NORTHERN WOLVES
AIR CONDITIONING

Request for Pricing / Date: 10/6/2026 / Rev 1

Project: **Sunrise Rye Brook - 900 King St, Rye Brook, NY 10573**

Request for revised pricing - value engineering

HKS PROJECT NUMBER
25004064.00DATE
07/15/26ISSUE
ISSUED FOR GMPSHEET TITLE
**INDEPENDENT LIVING
FIRST FLOOR PLAN -
MECHANICAL IL AREA**A/E/T NO.
M2010

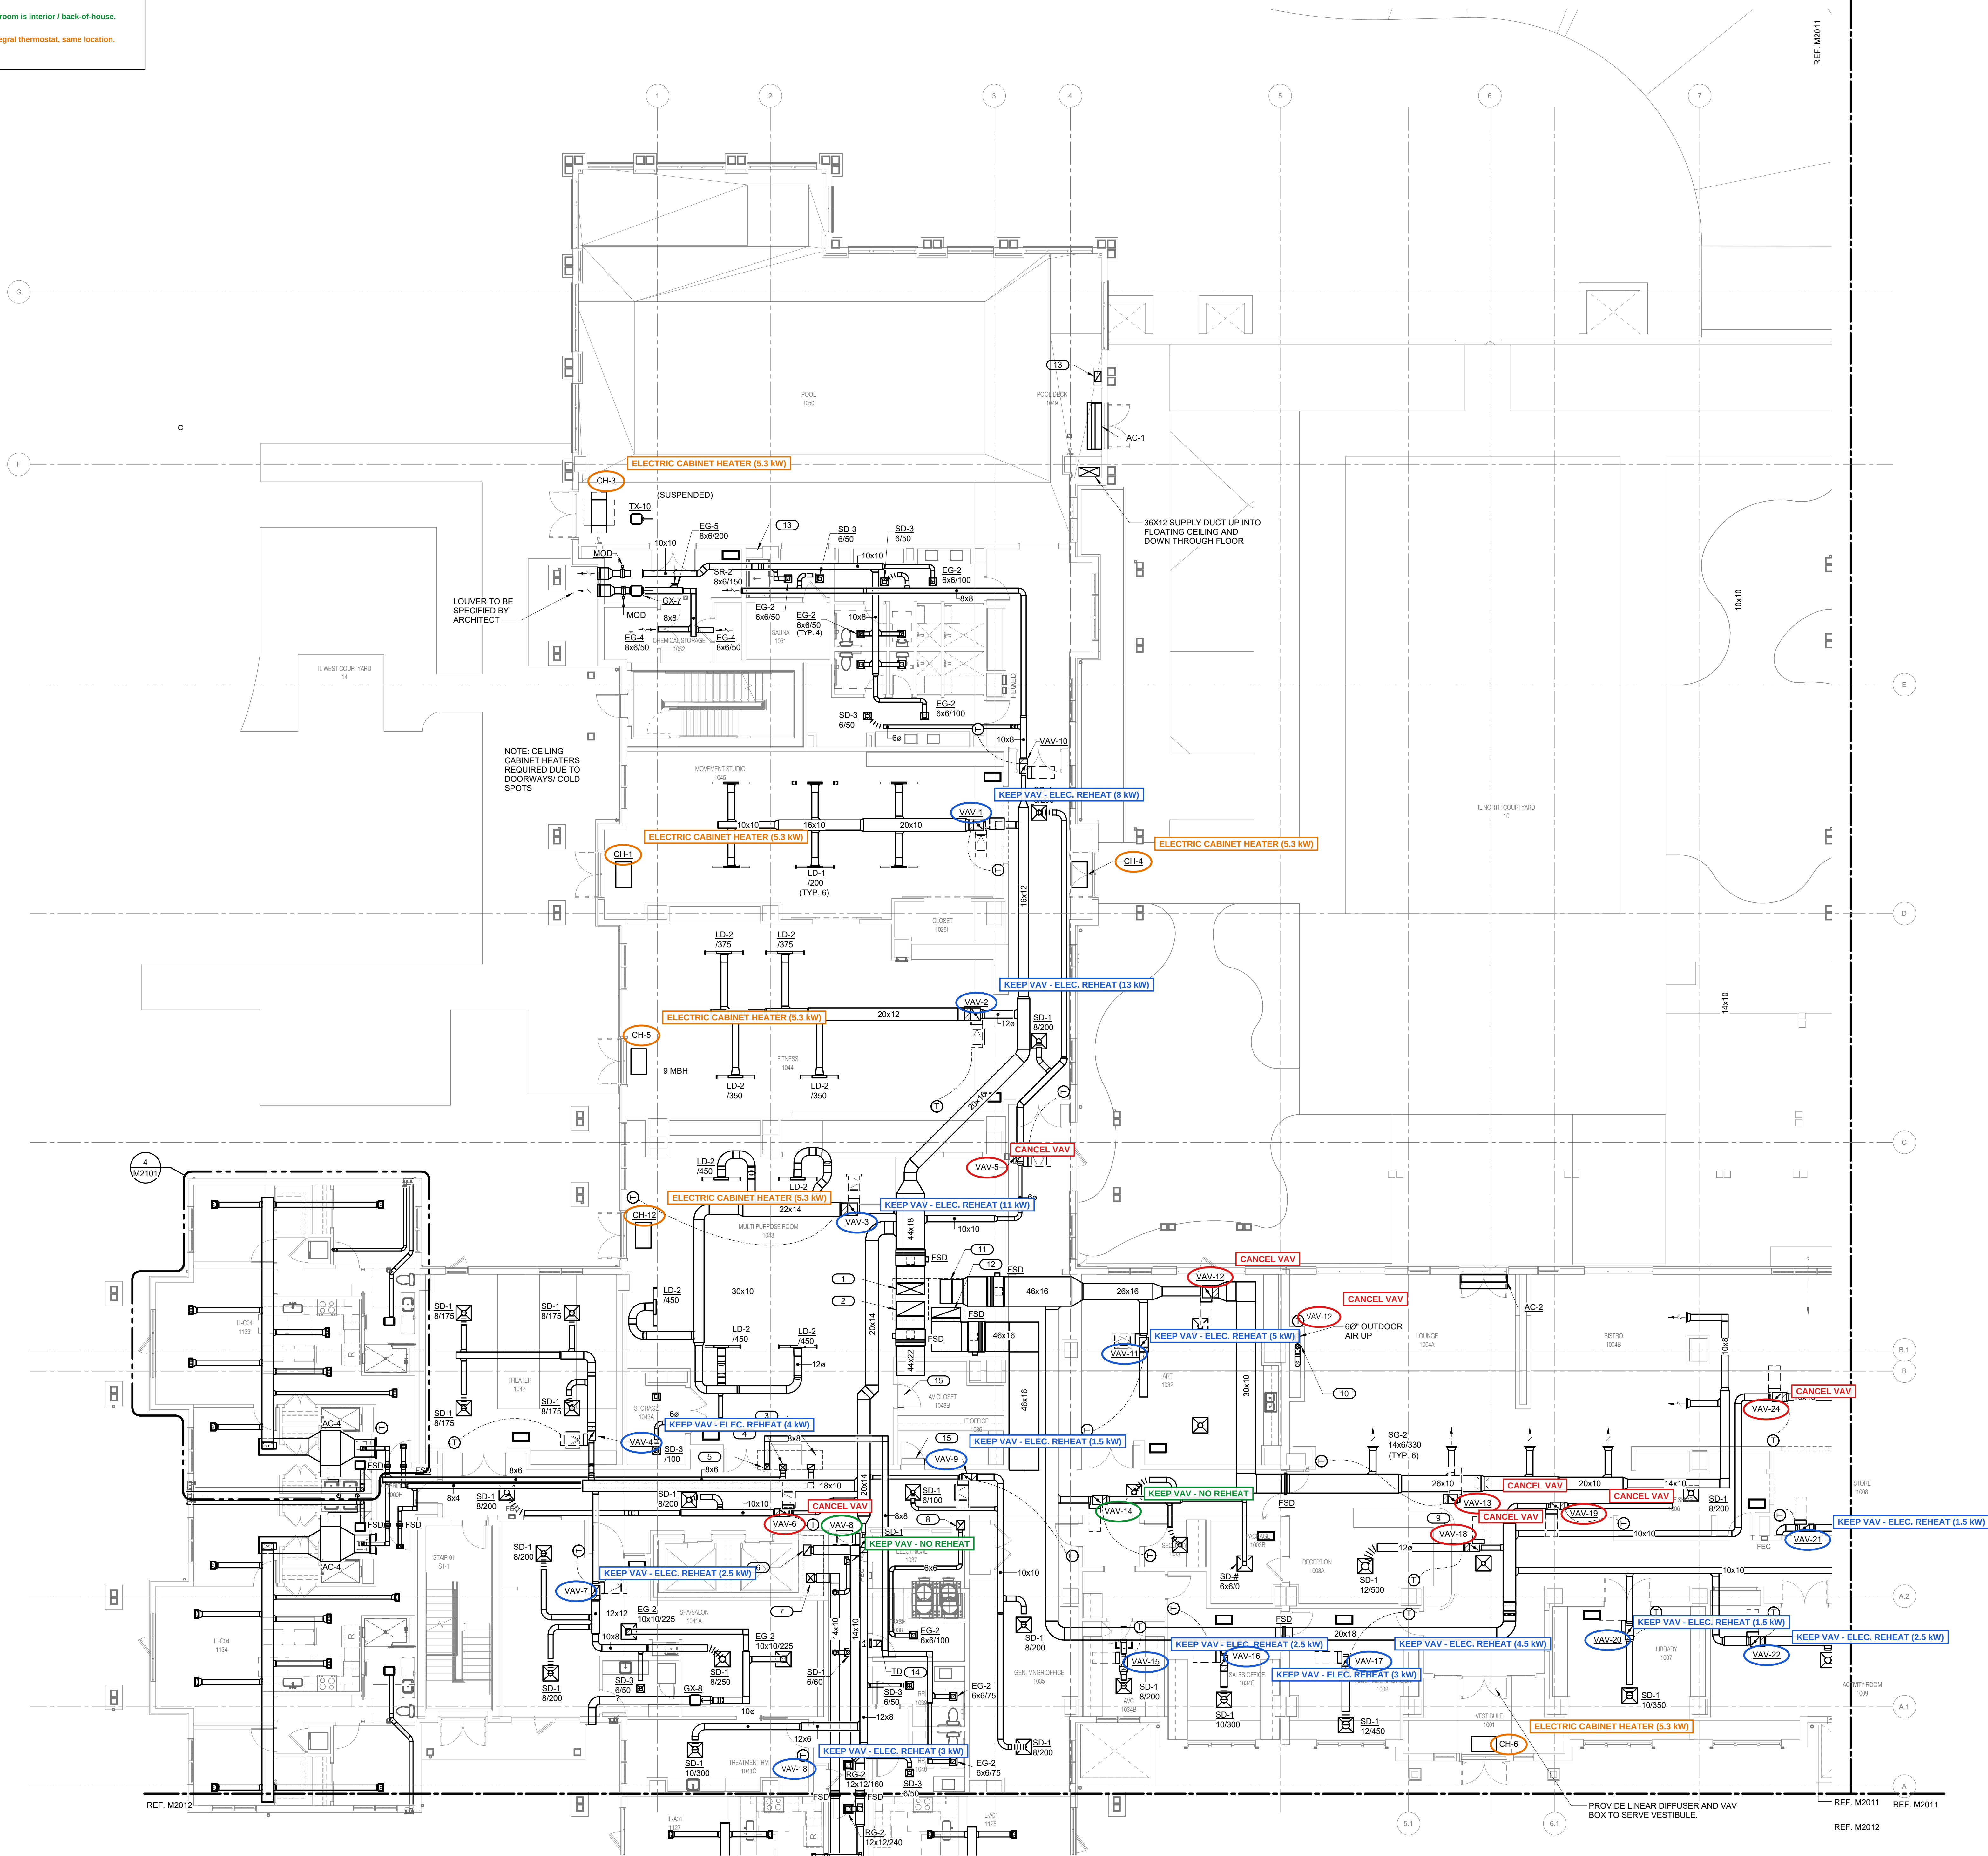
The heating design is being revised from a hot water boiler plant to electric heat. Please provide revised pricing for the items below: new items (section 1 and 2), credits for items deleted from your previous quote (section 3) and alternate deducts (section 4). Quote per line in the attached xlsx, with lead times. Electric heat: quote all heaters and electric reheat coils at 208 V / 3 ph (heaters rated at 208 V, kW as listed at 208 V - not 240 V units derated). Where a 208 V / 3 ph model is not available in the listed kW, note it and offer 208 V / 1 ph. Controls are standalone (no BMS): factory-mounted standalone controllers with wall thermostats / sensors.

1A. Single-duct VAV with factory electric reheat coil, SCR control, airflow switch, disconnect, standalone pressure-independent controller and wall thermostat (26)

Heating airflow at the scheduled minimum CFM; confirm minimum airflow for the electric coil. VAV-18A: second VAV-18 tag on M2010 (Treatment Rm 1041C), size per vendor at 3 kW.

M2011

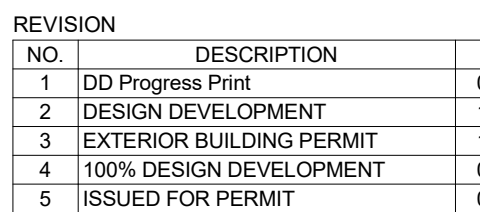
Attached: marked-up drawings M2010, M2011, M2013 (VAV terminals, cabinet heaters) and M2000, M2002 (basement unit heaters). Each item is marked with its tag and heat kW.

M2000

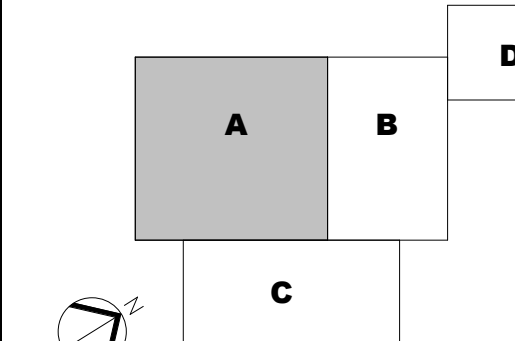
#	Location (basement)	Heat
2	Trash Collection B106 (exhaust make-up)	5 kW
3	Kitchen Storage B113	5 kW
4	Corridor B100	3 kW
5	Residents' Storage B115	3 kW
6	Team Member Lounge B119A	3 kW
7	Mechanical B118	5 kW
8	Trash room, AL south (400 CFM exhaust make-up)	5 kW
9	Storage room, AL south	3 kW
Total		35 kW
